City of Suffolk  
IFB #17062-CN  
February 15, 2017  
Purchasing Division  
442 West Washington Street, Room 1086  
Suffolk, VA 23434  
Phone: (757) 514-7522 Fax: (757) 514-7524  
<http://www.suffolkva.us/purchasing>

### ADDENDUM NO. 2

## Traffic Operations Center Upgrades

**A101**  
 1/20/13/01

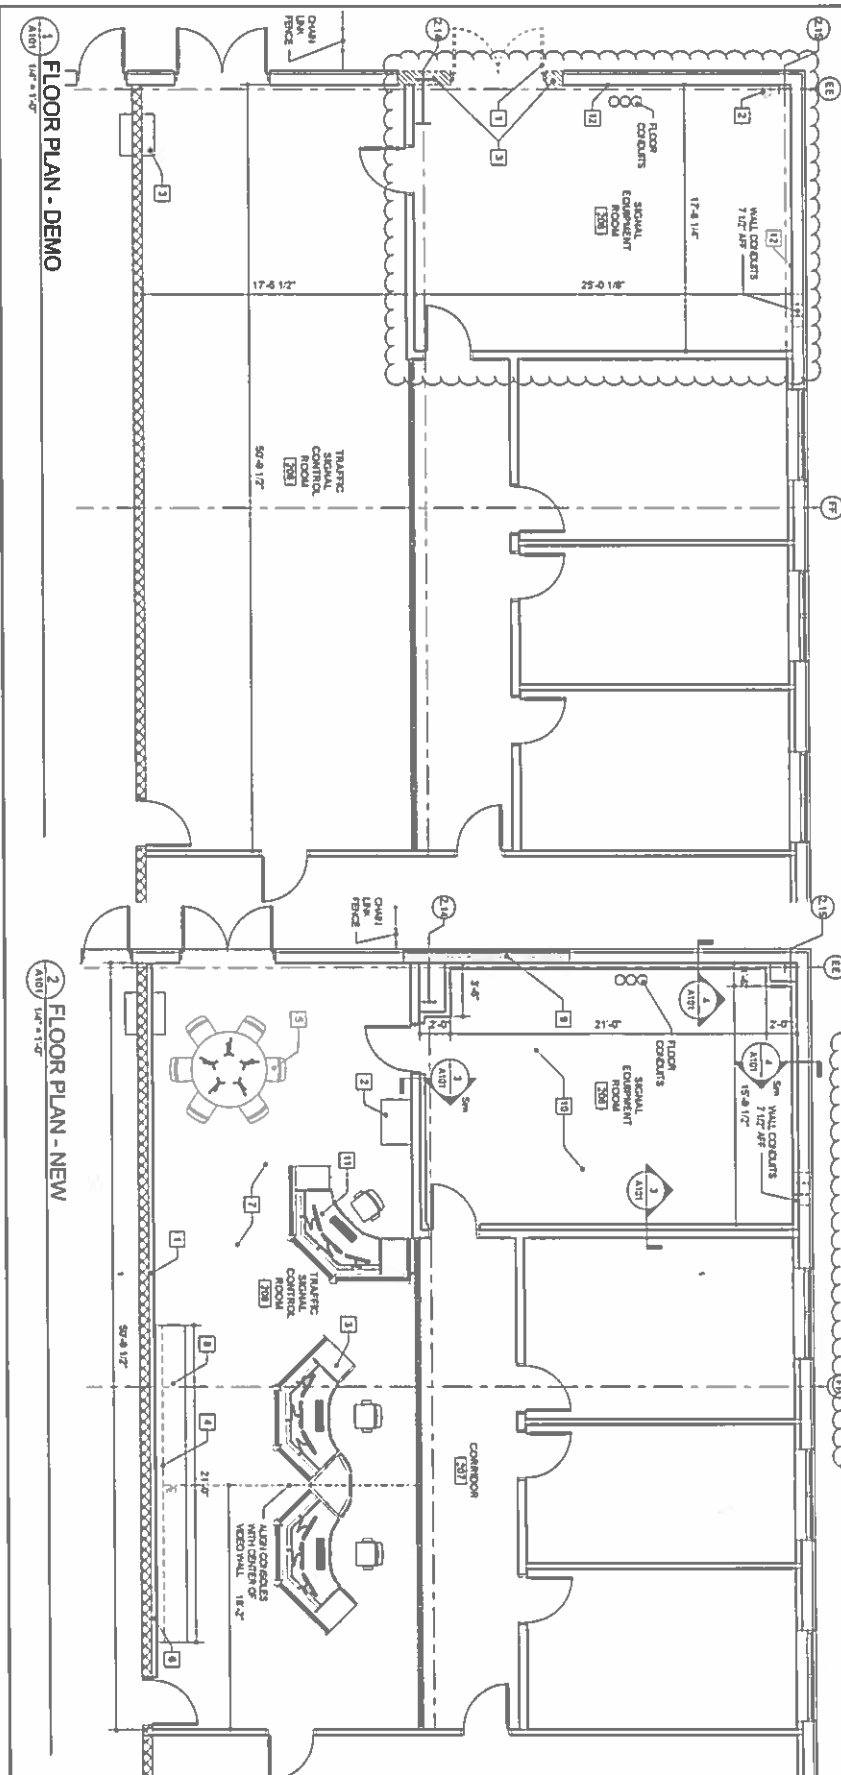
1. **Refer to the attached reissued Drawing Sheet A101, which revises the Demolition Plan and Demolition Notes.**
2. **Refer to the attached reissued Drawing E-302, which revises the coordination requirements for the door security access control systems (provided under a separate contract to the City).**

- GENERAL NOTES**
- REMOVE SEAL FROM DOOR FRAMES AND GLASS FOR DOORS TO SIGNAL EQUIPMENT ROOM AND EQUIPMENT ROOM FLOOR.
  - PROVIDE DOOR CONTACT AND ALARM FOR DOORS TO SIGNAL EQUIPMENT ROOM AND EQUIPMENT ROOM FLOOR.

- PROVIDE ALL DOORS TO SIGNAL EQUIPMENT ROOM AND EQUIPMENT ROOM FLOOR WITH SECURITY HARDWARE AND CARBON MONOXIDE DETECTOR TO COMPLEMENT SECURITY REQUIREMENTS WITH CITY'S SECURITY CONTRACTOR - COMMERCIAL SECURITY RESISTANCE INC. SEE DETAIL A101.
